**City of Richmond**  
Planning and Development Department

## Report to Development Permit Panel

**To:** Development Permit Panel  
**From:** Brian J. Jackson, MCIP  
Director of Development  
**Date:** December 14, 2011  
**File:** DP 10-545704  
**Re:** **Revised Application in Response to DPP Referral by Chen Design Studio for a  
Development Permit at 7900 Bennett Road**

1. Permit the construction of two (2) back-to-back duplexes at 7900 Bennett Road on a site zoned "Infill Residential (RI2)"; and
2. Vary the provisions of the Richmond Zoning Bylaw No. 8500 to permit a 0.5 m building projection beyond the vertical height envelope.

PLAN 1 DP 10-545704 DECEMBER 14, 2011

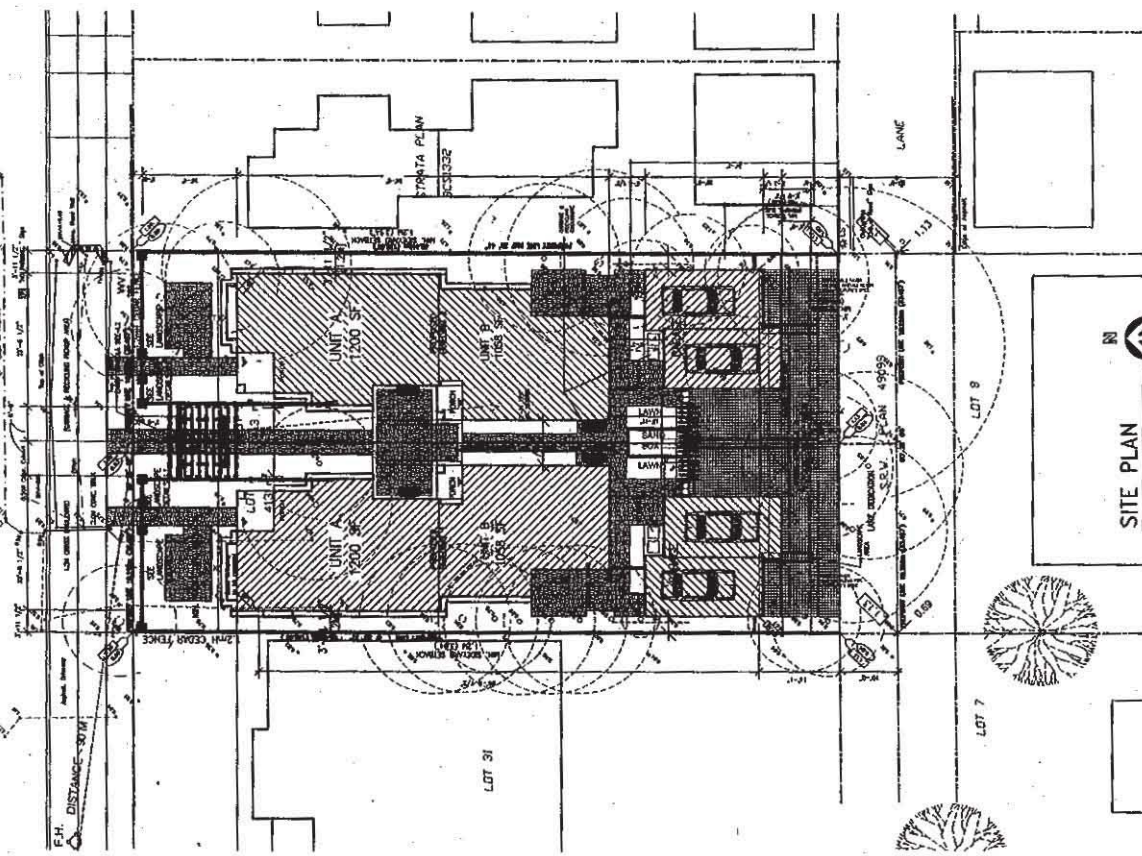
- (i) the landscaping scheme;*
- (ii) presentation to the lane;*
- (iii) access to the site;*
- (iv) on-site parking; and*
- (v) provision of useable outdoor space for each unit.*

- Reducing the Front Yard Setback from approximately 6.5m to 5.5m (4.5m required), detaching the garages, and shifting them to the south to address the panel's comments. This arrangement is in keeping with the Acheson-Bennett Typology and provides 3.0m Lane Dedication, 1.5m Temporary Right of Way and additional setbacks for the Garages (see note below).

Note: The garages have been shifted and stepped in plan to improve access, increase available open space to the common rear yard, and enhance architectural presentation to the lane. Transportation supports the 3.0m Lane Dedication, 1.5m Temporary Right of Way, with additional setbacks for the Garages to address the panel's comments (e.g., an additional 1.5m setback for the interior Garages, and 2.5m setback for the east/west Garages to the exterior property lines).

- To address the panel's comments, the garages have been shifted and stepped in plan to improve access, increase available open space to the common rear yard, and enhance architectural presentation to the lane.

*Presentation To The Lane:* To address the panel's comments, the garages have been shifted and stepped in plan to improve access, increase available open space to the common rear yard, and enhance architectural presentation to the lane.
